**Development of Draft Construction Safety  
Standards for Excavations. Volume 2**

**(U.S.) National Bureau of Standards  
Washington, DC**

# **Development of Draft Construction Safety Standards for Excavations**

## **An NBS/NIOSH Publication Volume II**

Figure 4. Components of the Shoring System

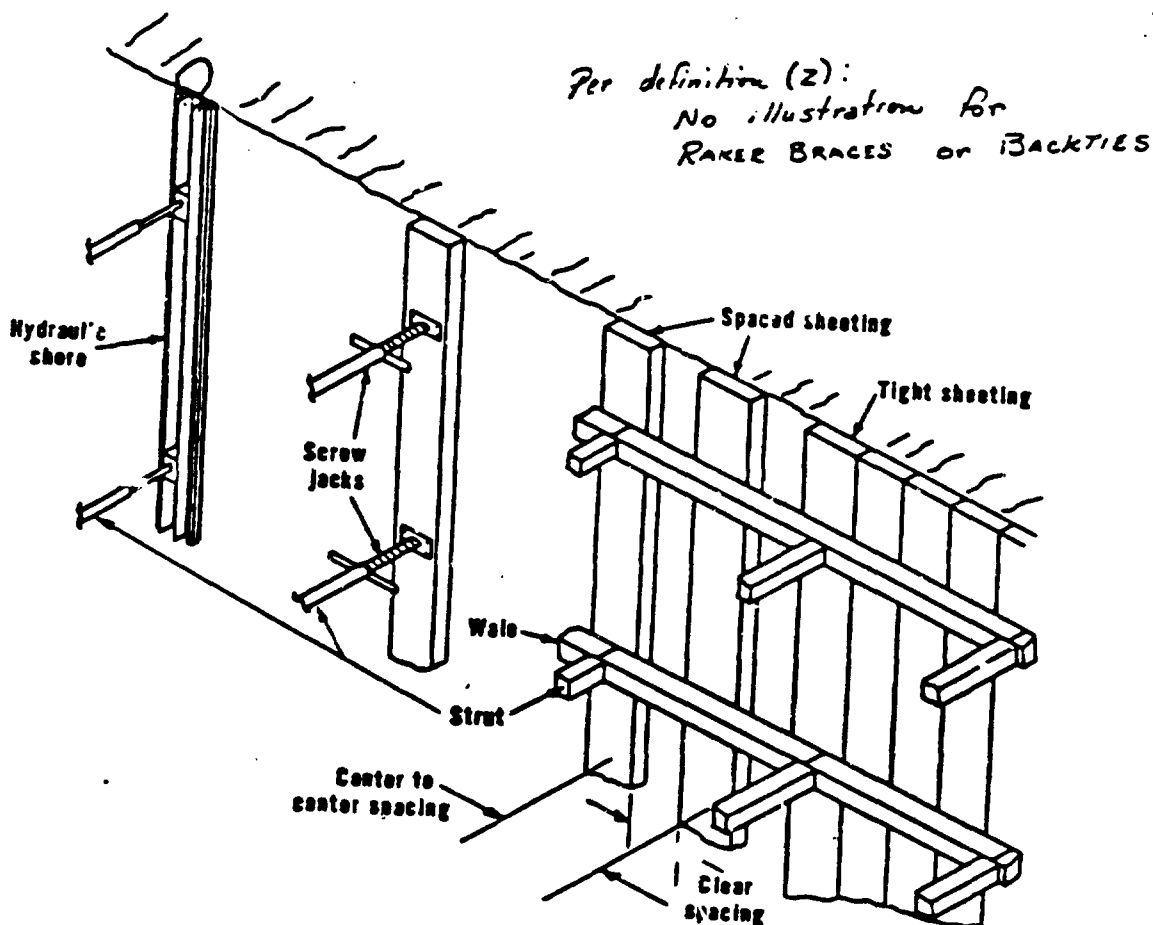
- ✓(w) Spaced Sheeting is sheeting in which the members bearing against the excavation wall are spaced (see Figure 6). Figure 4?
- ✓(x) Spalling is the continuous flaking and falling of soil or rock from an unsupported trench wall.

- ✓(y) Standard Practice is the trenching and shoring practice in Section 1926.652(b).
- ✓(z) Struts are the primary support members of a shoring system including but not limited to cross braces, raker braces, jacks and backties (see Figure 6) Figure 4?

Raker braces or backties are not illustrated
